FOOD AND DRUG ADMINISTRATION
CENTER FOR BIOLOGICS EVALUATION AND RESEARCH

Final CMC review

Subject: Final CMC Review of Portola's BLA for Coagulation Factor Xa (Recombinant), Inactivated [ANDEXXA]

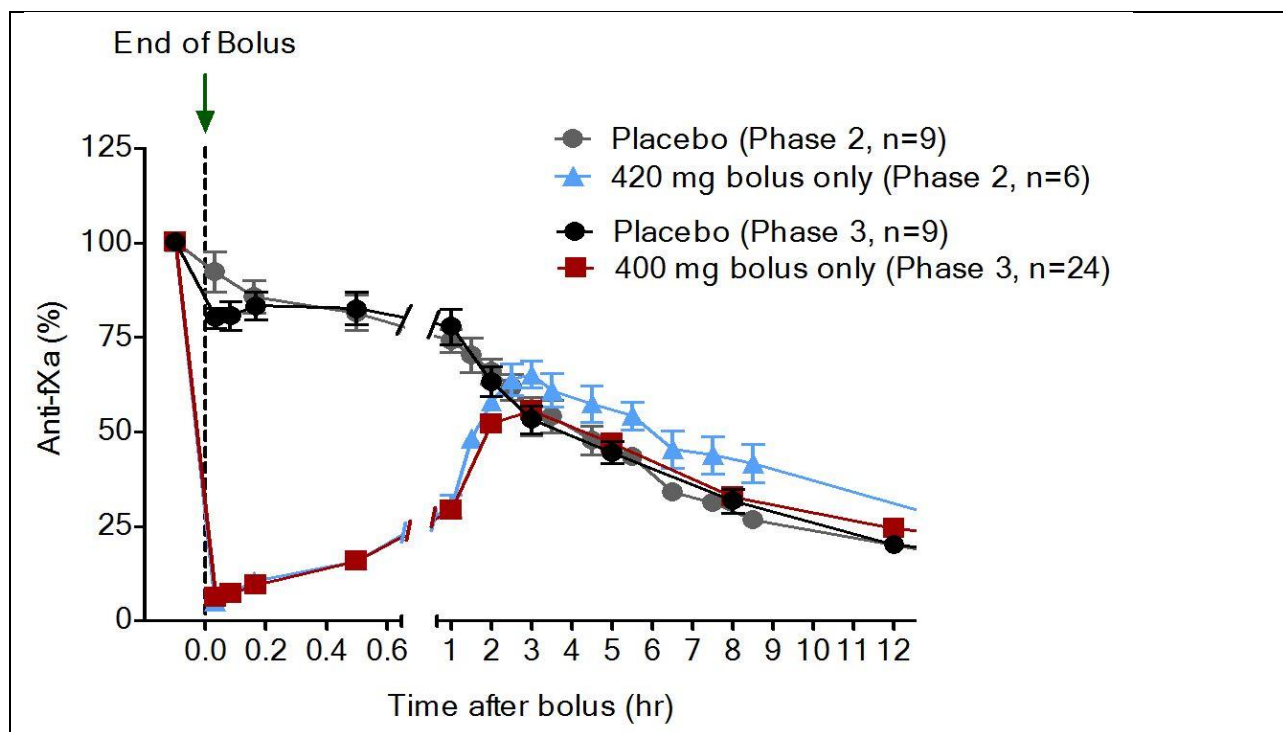
In communications during the IND, Portola often presented the results of the anti-FXa activity assay as % of pre-ANDEXXA treatment, see Figure 16. This approach is suitable for comparing the ANDEXXA and placebo arms of the clinical trials. For example, Figure 16 demonstrates that anti-FXa activity returns to placebo levels within 2 hours after ANDEXXA administration. However, the percent presentation does not allow the comparison of the magnitude of the reversal of anti-FXa activity with the numerical values of the pharmacological range of FXa inhibitor concentrations in blood. Specifically, for the reversal of anti-FXa activity to be reasonably likely to predict clinical benefit, the remaining level of anti-FXa activity should be below the clinically effective

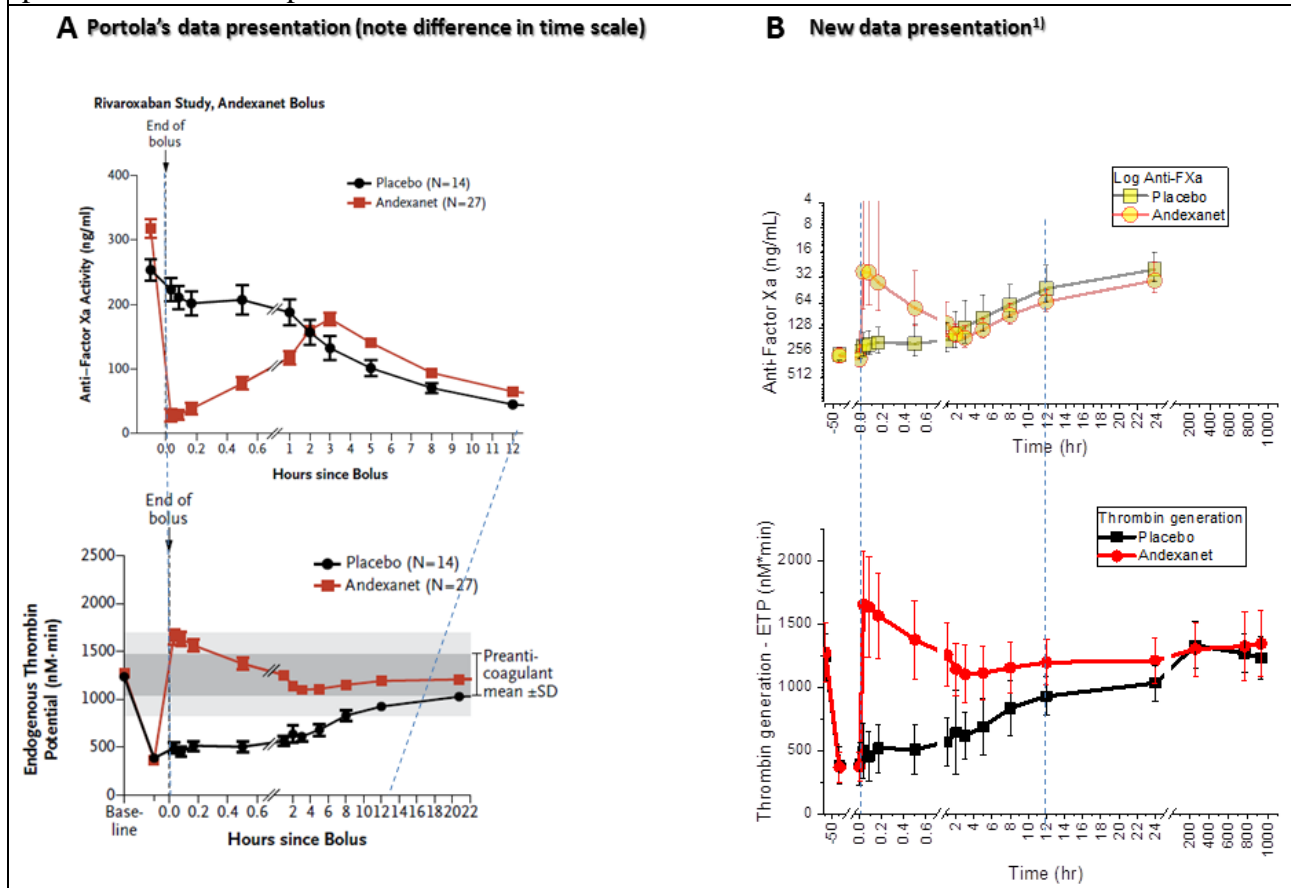
- 1. The data in the NEJM paper presented in Figure 17 below demonstrate that the reversal of anti-FXa activity was very brief (anti-FXa activity levels in the ANDEXXA treatment group returned to those in the placebo group within 2 hours) while the elevation of TGT is much longer (TGT was elevated for at least 22 hours).*

(which is sustained). Therefore, I re-plotted these graphs using the same time scales, see Fig. 17B.

Furthermore, to assist with the visual analysis of the pro-coagulant effects of ANDEXXA, on Fig. 17B, I changed the direction of the anti-FXa activity axis such that an increase in anti-FXa activity will be directed downwards. The revised Fig 17B illustrates that ANDEXXA has a much stronger and longer effect on the TGT than on the anti-FXa activity assay.

Figure 21: Duration of TFPI inhibition and anti-FXa activity reversal actions of ANDEXXA. A. Data on TFPI activity and TFPI antigen inhibition in healthy volunteers without

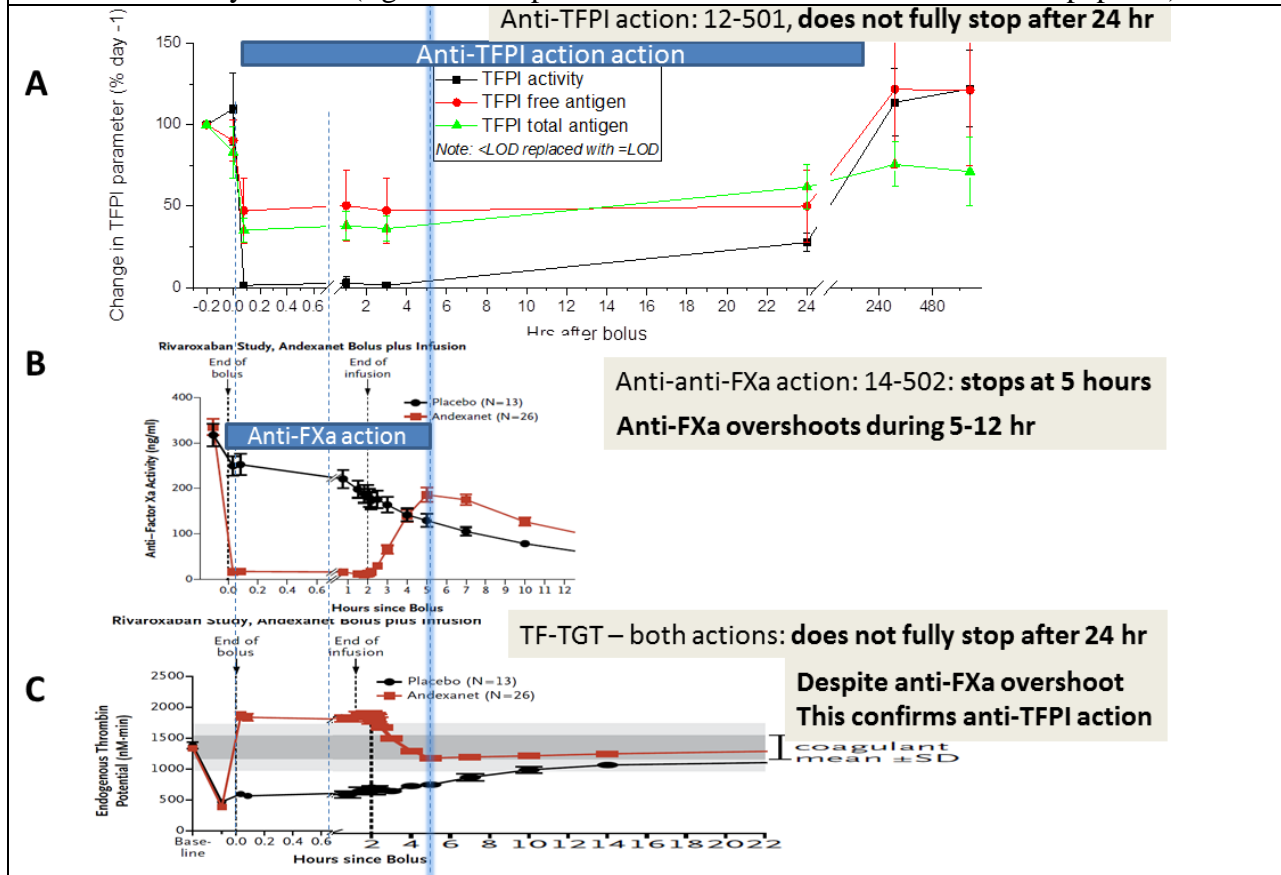
Reviewer's comment: I conclude that anti-FXa reversal is very short (about 2 hours) and TFPI inhibition is prolonged (at least 24 hours but possibly much longer) and therefore all of the sustained elevation of TGT is probably a result of TFPI inhibition by ANDEXXA.

Figure 22: Estimation of the relative contributions of anti-FXa reversal and TFPI inhibition actions of ANDEXXA to the observed elevation of TGT in Phase 3 studies published in

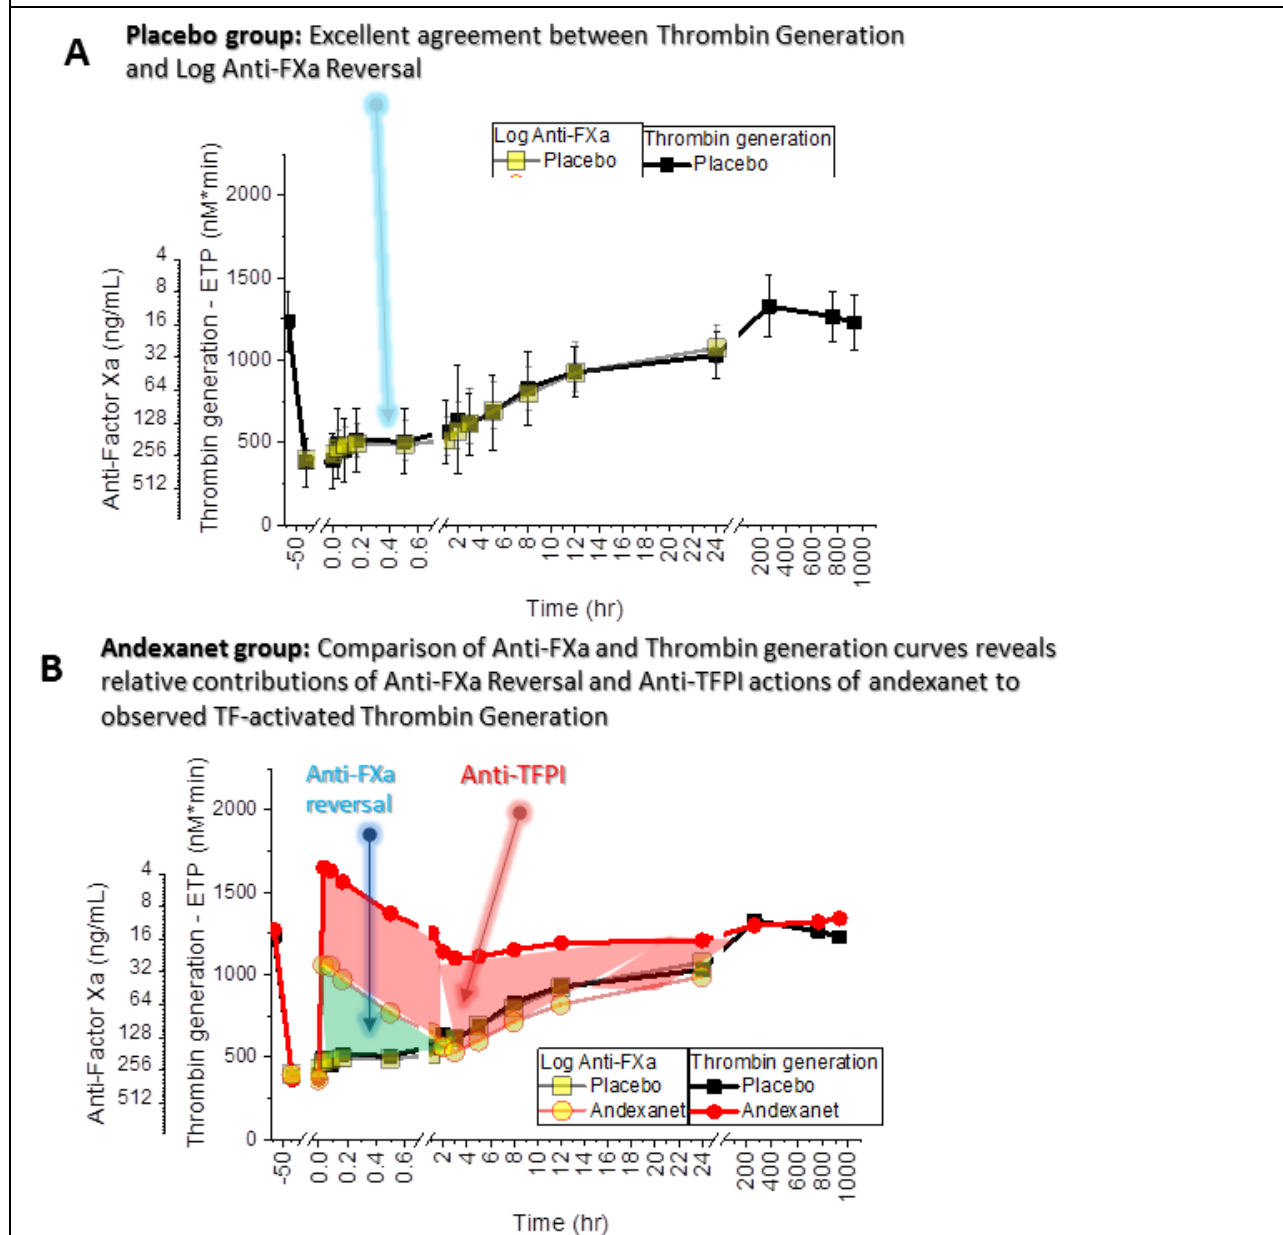
Reviewer's comment: I conclude that TFPI inhibition may be responsible for ~50% of the observed TGT elevation during the first hour after ANDEXXA bolus and 100% of elevation for the remaining 24 hours or longer, see Figure 22.

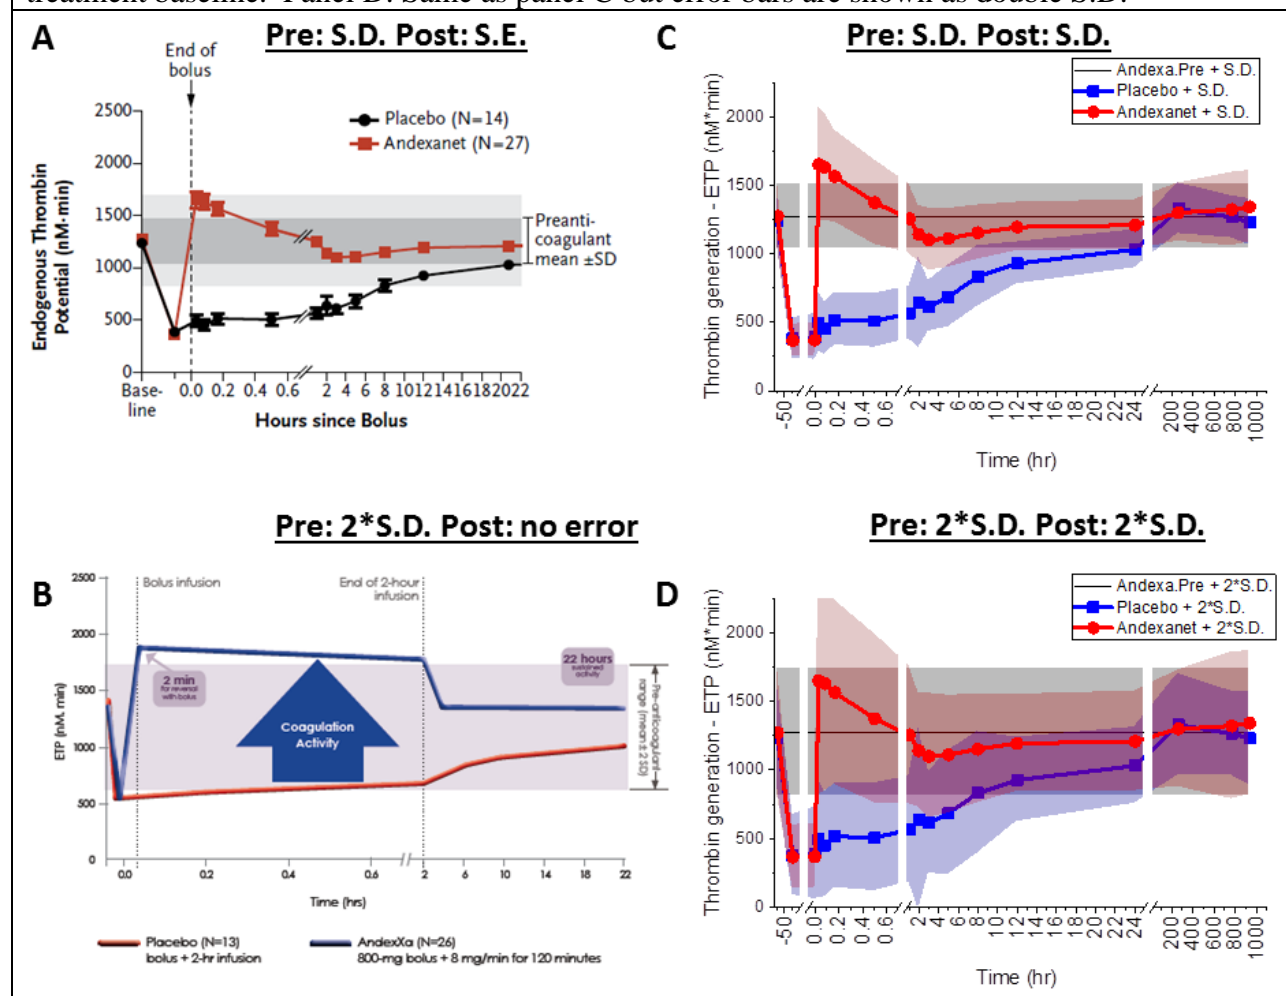
Because TFPI inhibition is potentially thrombogenic and is not as transient as the reversal of anti-FXa activity, the *Prescribing Information* should include accurate descriptions of the duration and magnitude of both outcomes of the effect of ANDEXXA in the clinical trials. I recommend requesting revisions to every sections in the BLA in which the mechanism of action of ANDEXXA

I recommend modifying the promotional materials (and all related figures in the BLA) such that the time courses of TGT are plotted using *standard deviation* of the mean for all data points, which should include the pre-treatment (the so-called normal TGT range) for the ANDEXXA and placebo arms of the study. As evidenced from Figure 25B, Portola's proposal to compare two standard deviations of the pre-treatment levels of TGT with a *standard error* of the mean for the ANDEXXA arm creates an incorrect impression that the elevation of TGT after ANDEXXA administration remains within the "normal TGT range" while in fact a substantial elevation over the pre-treatment baseline was observed in the Phase 3 studies.
